CITY OF DELAND
REGULAR MEETING OF THE PLANNING BOARD
JUNE 15, 2022 AT 5:00 PM
CITY HALL, COMMISSION CHAMBERS
120 SOUTH FLORIDA AVENUE

AGENDA

**CITY OF DELAND
PLANNING BOARD REGULAR MEETING
MINUTES
WEDNESDAY, MAY 18, 2022 -5:00 P.M.
CITY HALL**

PLANNING STAFF REPORT **to** **PLANNING BOARD**

PROJECT AREA -
38.64± AC.

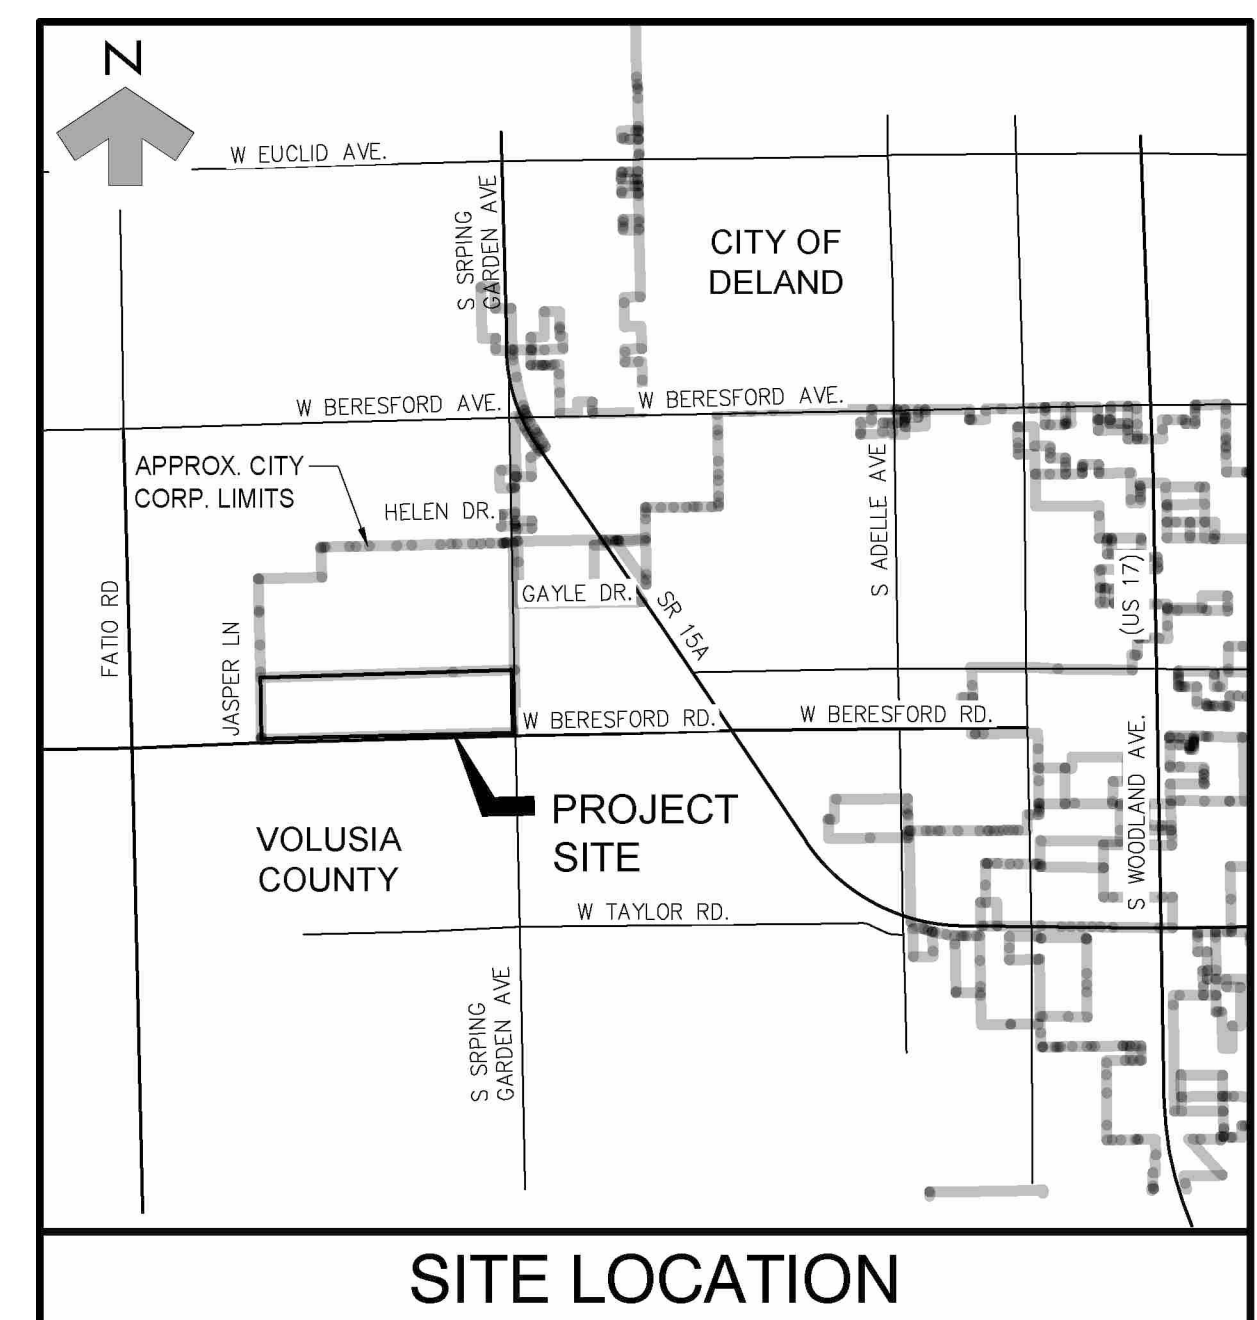
1. Beresford Avenue and S. Spring Garden Avenue are Volusia County maintained roads. County Use Permit is required.
2. 1. Civil Engineer office phone number on Stormwater Report cover page does not match Construction Plan Cover Sheet C01. Please revise.

2. Page 1 – Project Description: Report narrative states project area as 36.63 acres in multiple places. However, the construction plans Cover Sheet C01 states project area as 38.64 acres. Please clarify different in project areas between drainage report and construction plans. Will this change the drainage analysis and calculations in sections B thru D.

**GRADING &
DRAINAGE
PLAN**

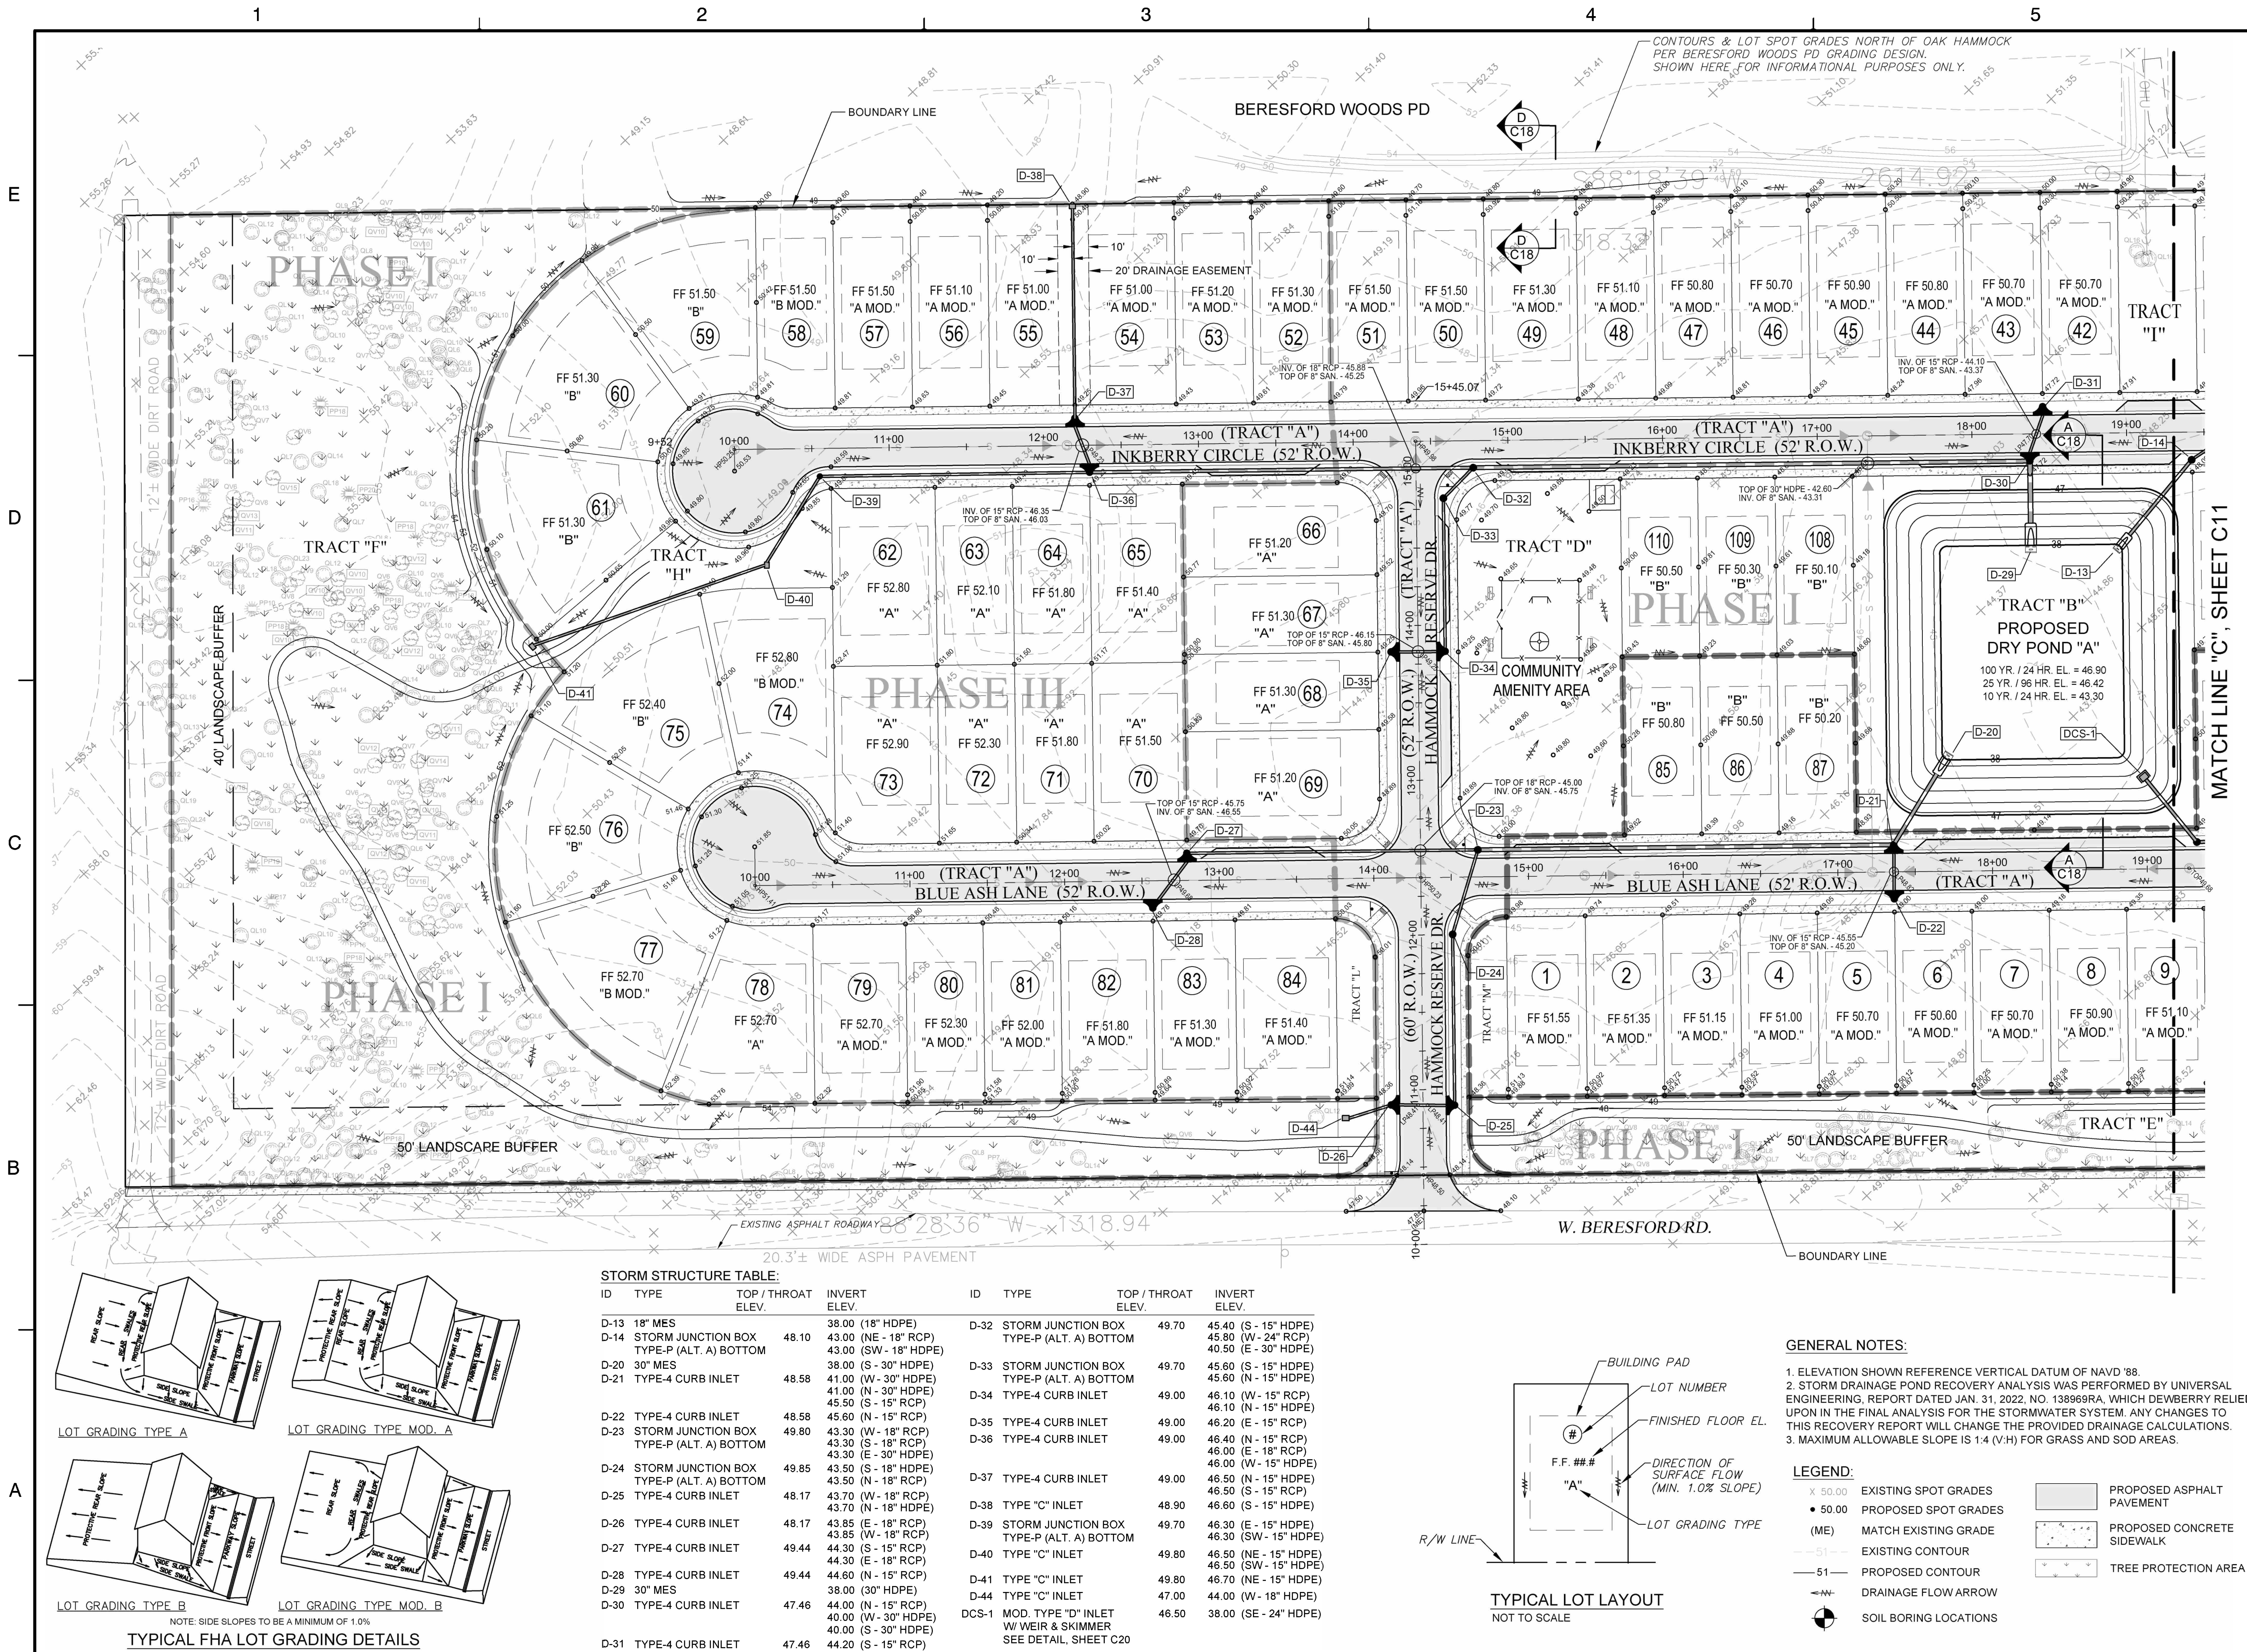
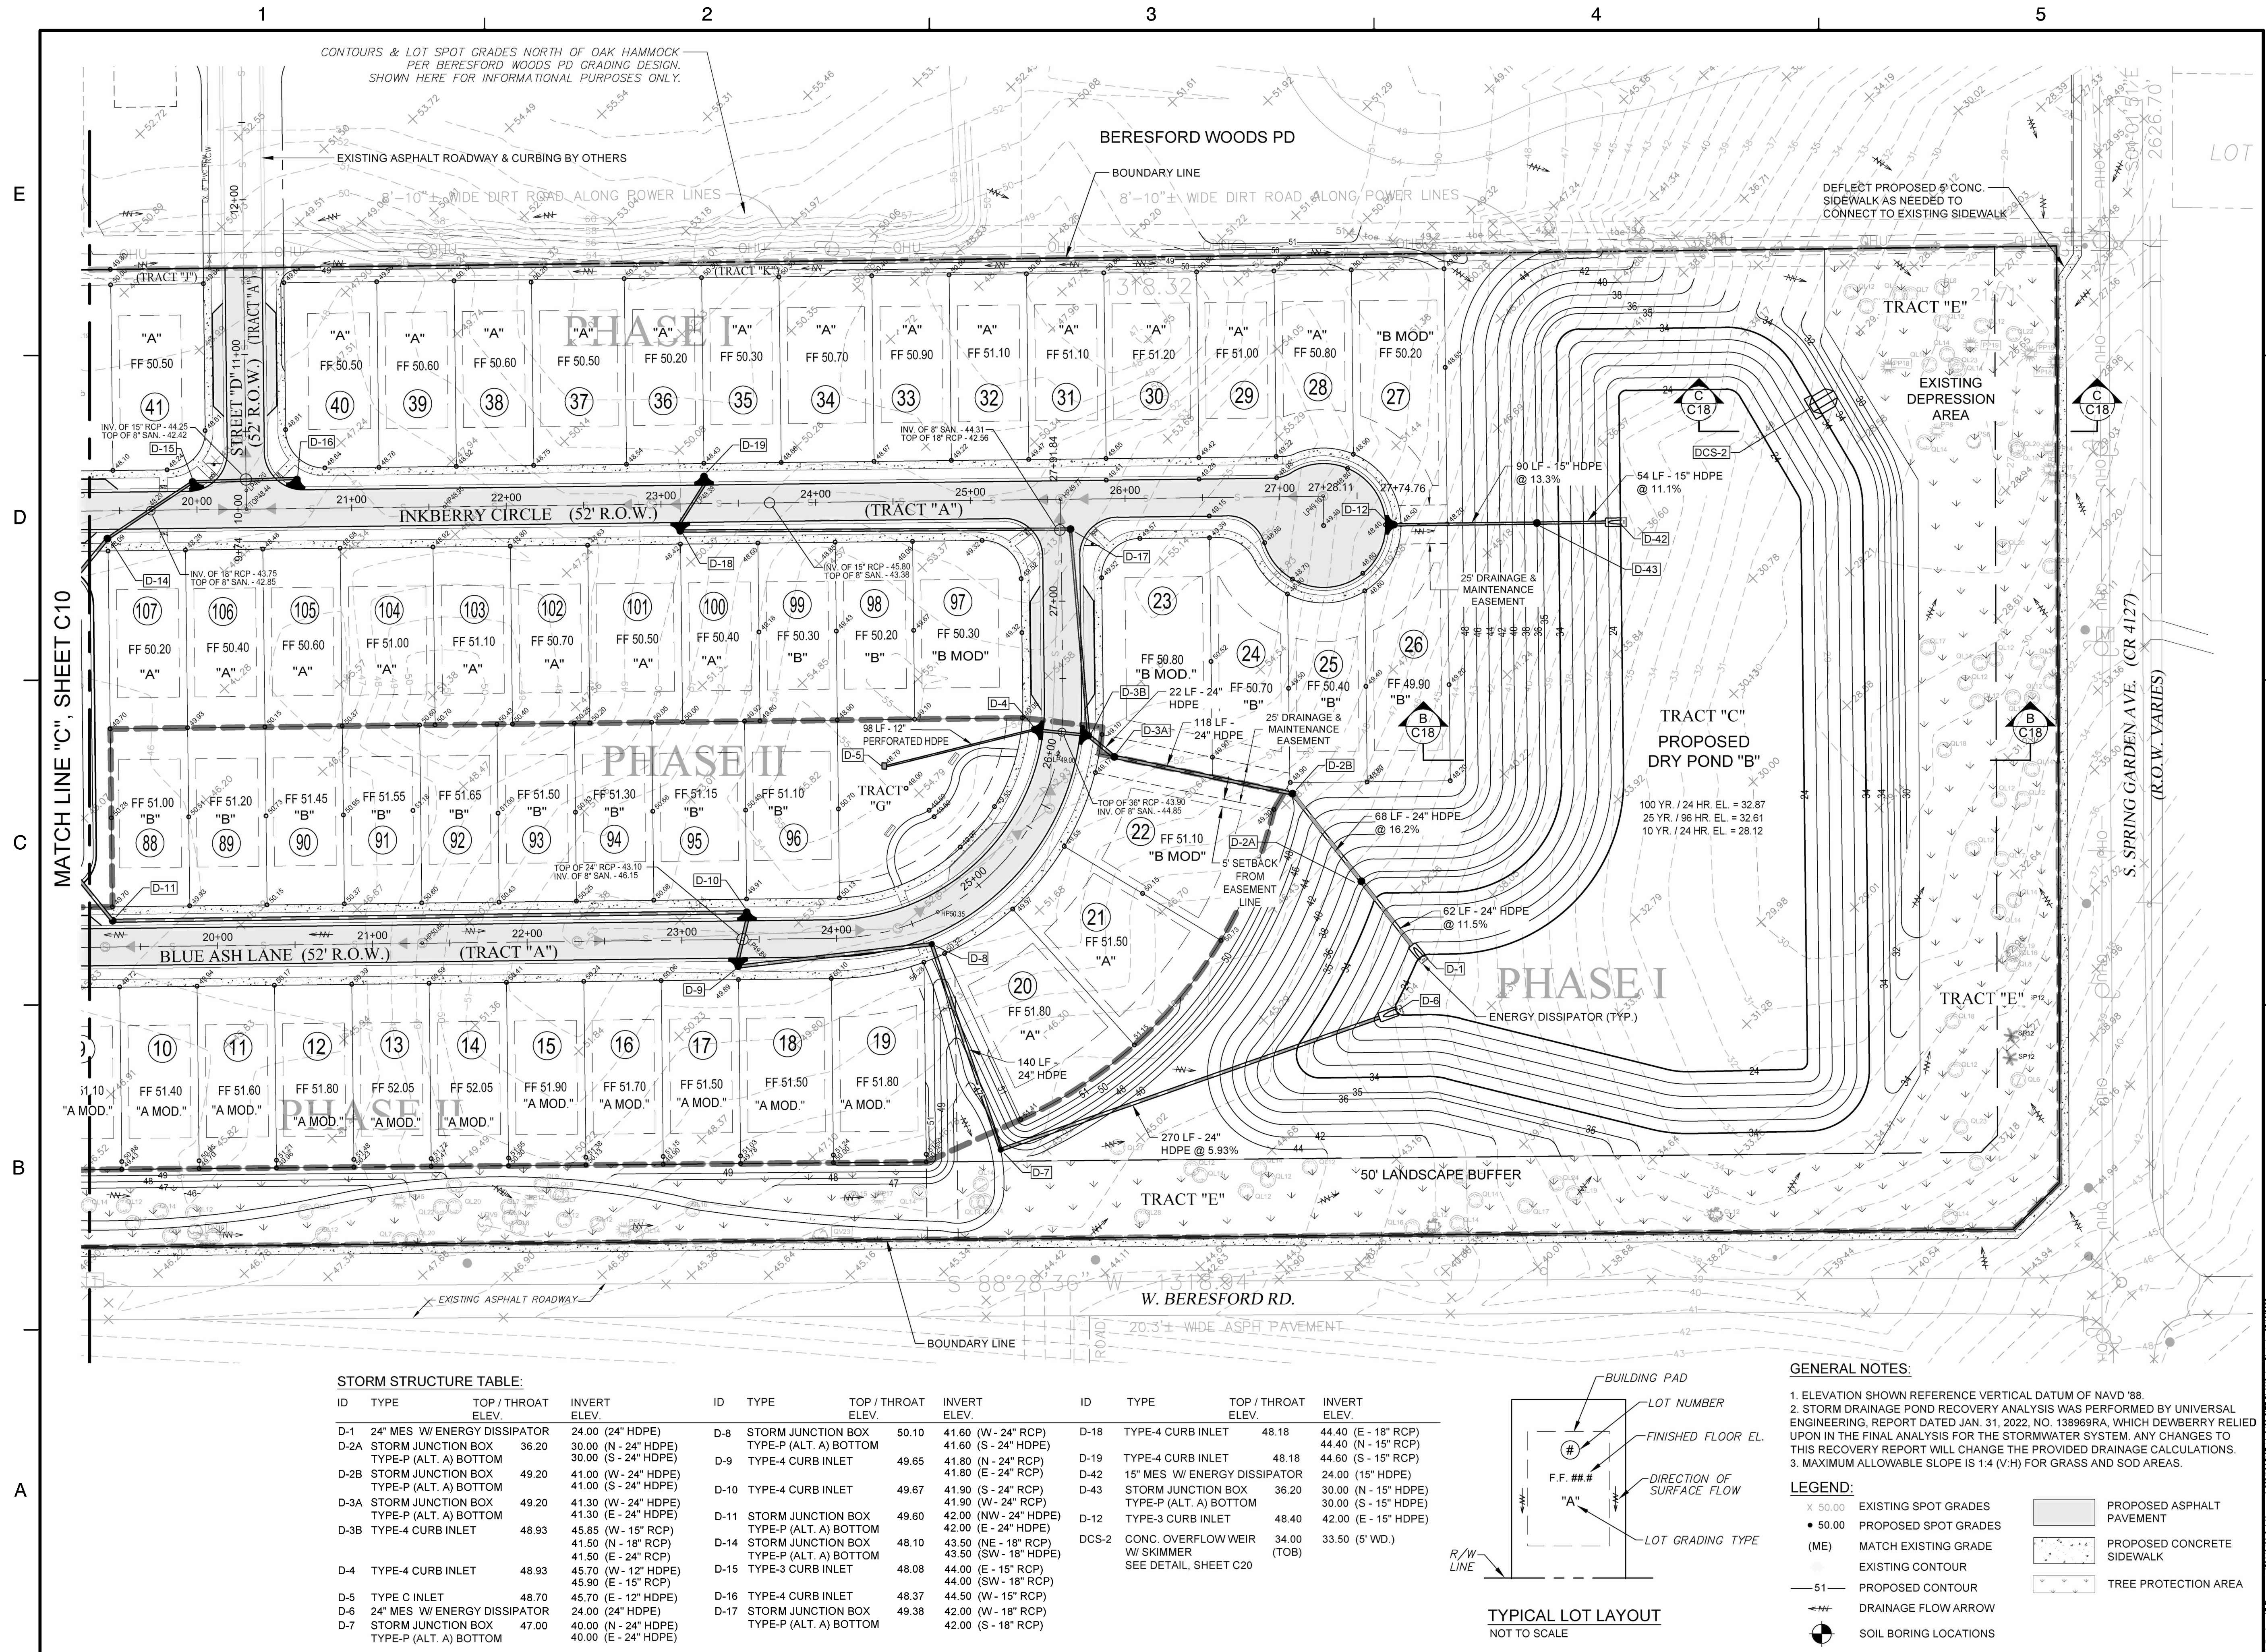
3. Please move lot grading type text to be within the lots for Lot 76 and 77.
4. Lot 78 and 79 grading Type "A MOD" spot shot locations do not match lot grading detail.

1. Is it possible to move curb inlets D-15 and D-16 away from the curb return radius and HC ramps?
2. Curb inlet D-3 is located in middle of the 25' drainage easement to Pond B. There is concerned in future that inlet top will be damaged by maintenance vehicles accessing the pond.
3. Can the drainage easement width be increased or the storm pipe move further away from Lot 22 house pad? Pipe is about 10 feet deep and located only 11 feet away from house pad. There are safety concerns.
4. Can storm pipe between Inlet D-7 and D-8 be shifted further away from Lot 20 house pad? Pipe is over 10 feet deep and located less than 10 feet away from house pad. There are safety concerns.
